**CITY OF OPELIKA
PLANNING COMMISSION MEETING
APRIL 27, 2021
3:00 P.M.
MEETING CHAMBERS
OPELIKA MUNICIPAL COURT
300 MLK BOULEVARD**

3. Camelot Townhomes Subdivision, Phase 1, 9 lots, Merlin Street, Blake Rice, Final Approval

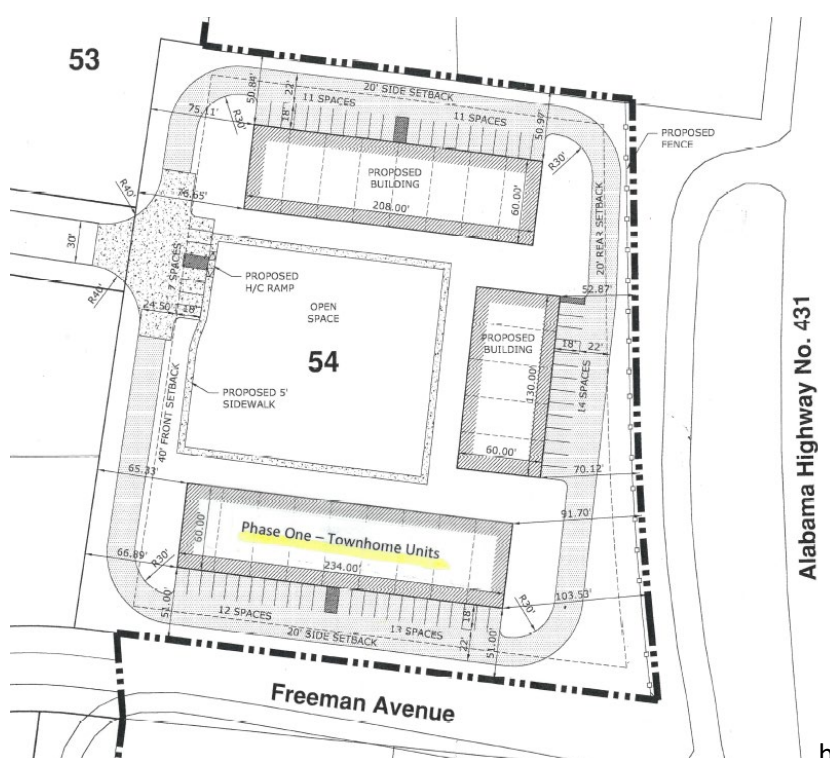
1. Add "ROW Varies" or similar for Old Lafayette Highway.
2. Add a signature line for the Chairman of the Planning Commission.
3. Add a note on plat who will maintain all common areas and include that the City of Opelika is not responsible to maintain the private driveway on Lot 55-B-2.

4. Install landscaping, grass & ground cover, and residential buffer for phase one.
5. Install curbs, asphalt private driveway from Merlin Street to parking spaces; stripe parking lot (14 parking spaces, 1 handicap space) and install sidewalks.

6. Fire lane requirements must be approved as determined by the Fire department.
7. If a dumpster is proposed for townhome units an enclosure with an opaque fence on all sides and an opaque double gate installed at a height so the dumpster cannot be seen outside the fence.

8. After site inspection and approval of the above improvements by staff, then plat signatures and recording of final plat will be completed.

April 2021 Subdivision – 7 Camelot Townhomes

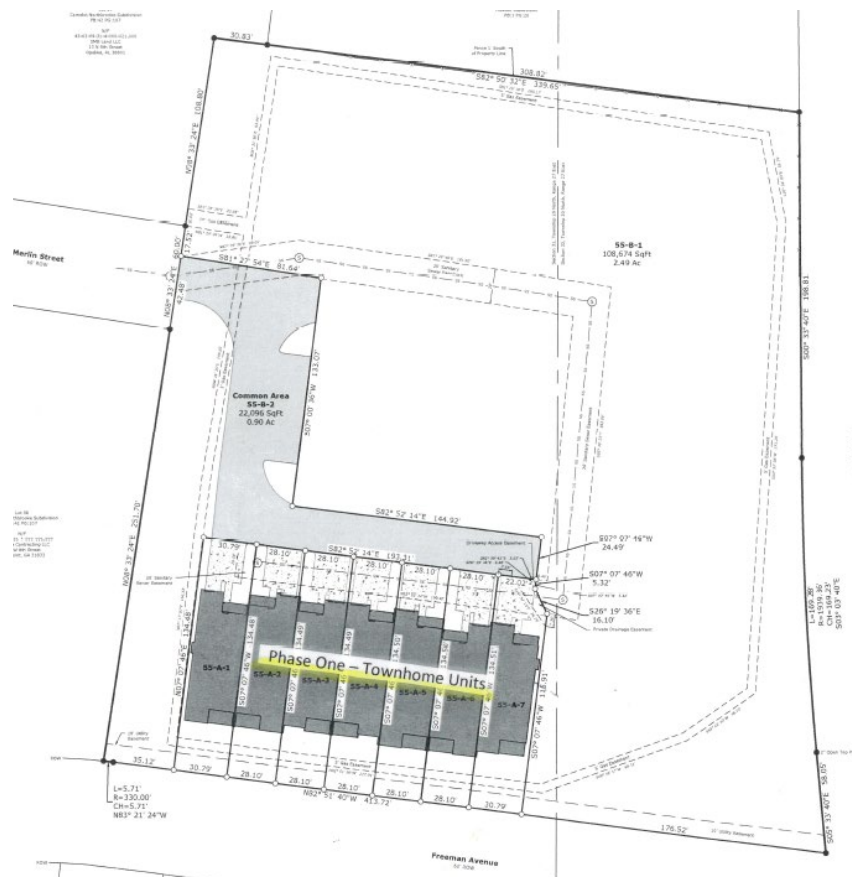
lots. Each townhome lot includes a front and rear yard. The townhome layout today has minor changes from the July 2018 site plan layout (See page 3 for comparison). In today's subdivision, the front door and parking spaces for townhome units are now facing the north property line not the south property line toward Freeman Avenue as shown on the 2018 site plan. Also, the number of townhome units for phase one decreased from nine units to seven units. The 2018 landscape plan met requirements for the most part; an updated landscape plan is included in your packet. The revised plan includes a residential buffer along the south property that runs parallel to Freeman Avenue, and landscaping for the parking lot (14 parking lot points) is added.
